Unbalance

Rev. 3

MICHAEL PAUL

Figure 145–22—PSE PI unbalance specification and system resistance unbalance

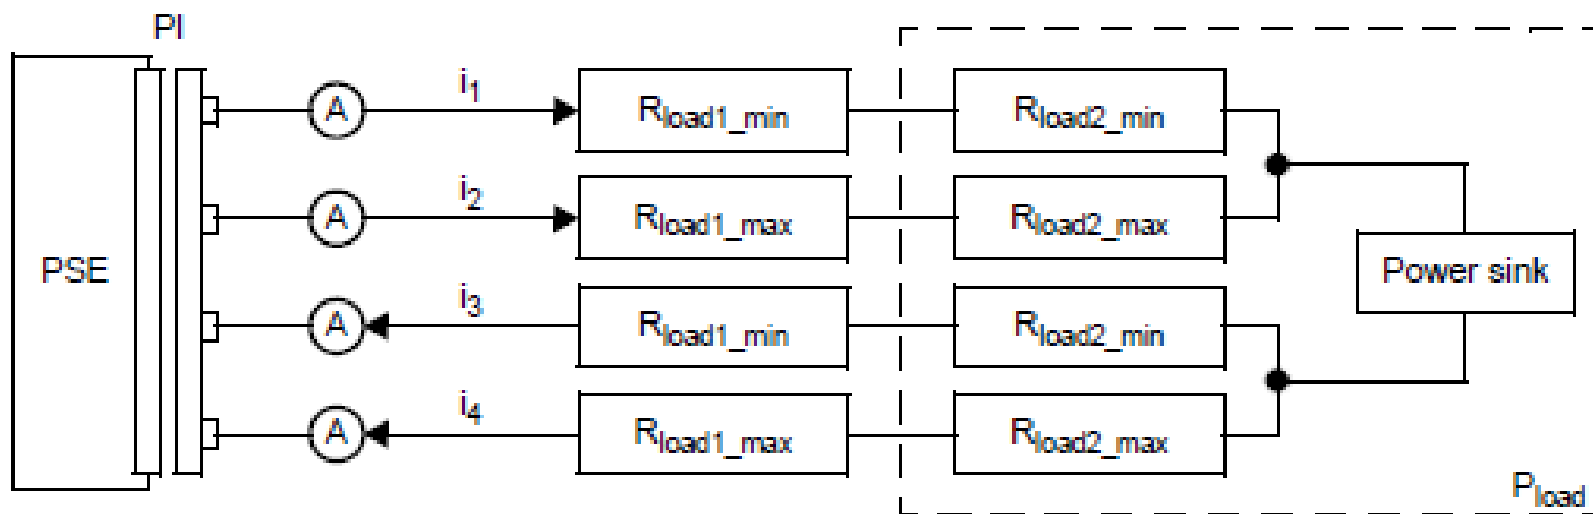
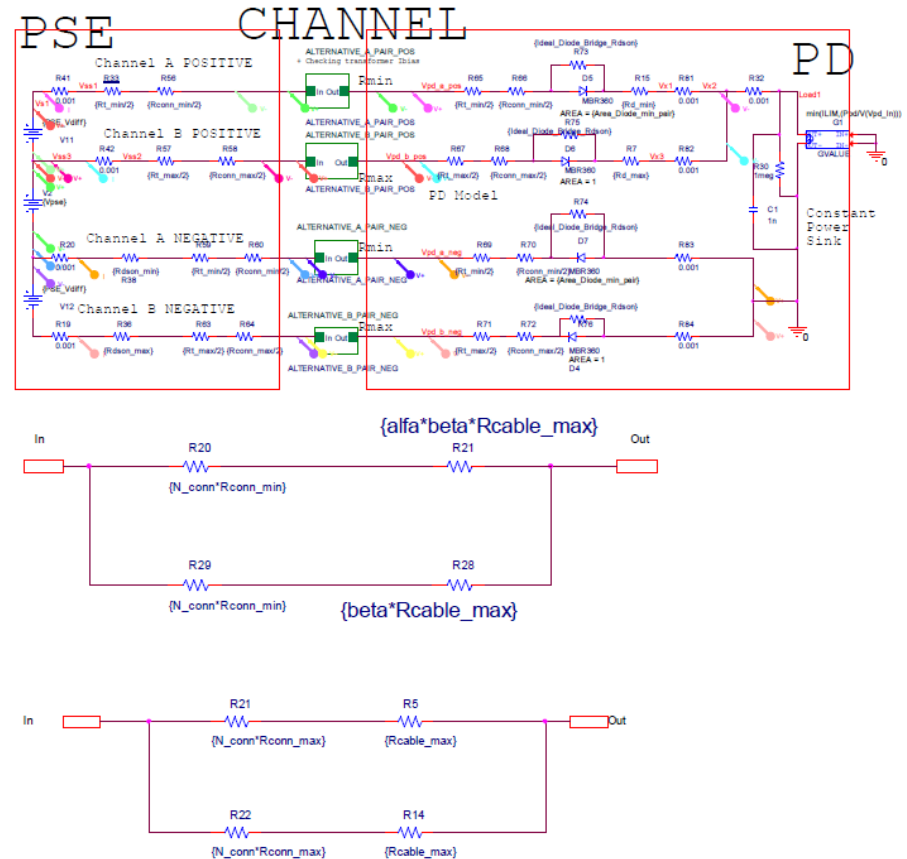
- ▶ Draft 3.1 $I_{\text{Unbalance-2p}}$ was changed to 560mA to provide margin.
 - Now, using the PSE test from table 145-18, $R_{\text{PSE_alpha}}$ can be changed to 2.67 and pass the compliance test
 - That is the PSE can be more unbalanced and pass the hardware compliance test

- ▶ Plugging $R_{PSE_alpha} = 2.67$ back into the System Unbalance model gives $I_{con-2p,max} = 571mA$
- ▶ This PSE passes the compliance test but may fail to interoperate

- ▶ We need two unbalance numbers
 - $I_{\text{Unbalance-2p}}$ for the hardware unbalance test (component unbalance contribution)
 - $I_{\text{Con-2p-unb}}$ for the system at runtime (software-controlled current threshold)

- The hardware test limit must be less than the runtime unbalance limit to ensure margin
- ▶ $I_{\text{Unbalance-2p}}$ is the hardware unbalance test
 - PSEs and PDs should not exceed $I_{\text{Unbalance-2p}}$ when connected to the test load/source

- $I_{\text{Unbalance-2p}}$ should use the $I_{\text{Con-2p-unb}}$ numbers from Draft 3.0
 - Draft 3.0 $I_{\text{Con-2p-unb}}$ numbers define system performance given PSE, cable and PD unbalance allocations

- ▶ $I_{\text{Con-2p-unb}}$ is the runtime test
 - A PSE should not remove power from a PD until at least $I_{\text{Con-2p-unb}}$ is drawn from a pairset

- $I_{\text{Con-2p-unb}}$ should maintain the numbers specified in Draft 3.1
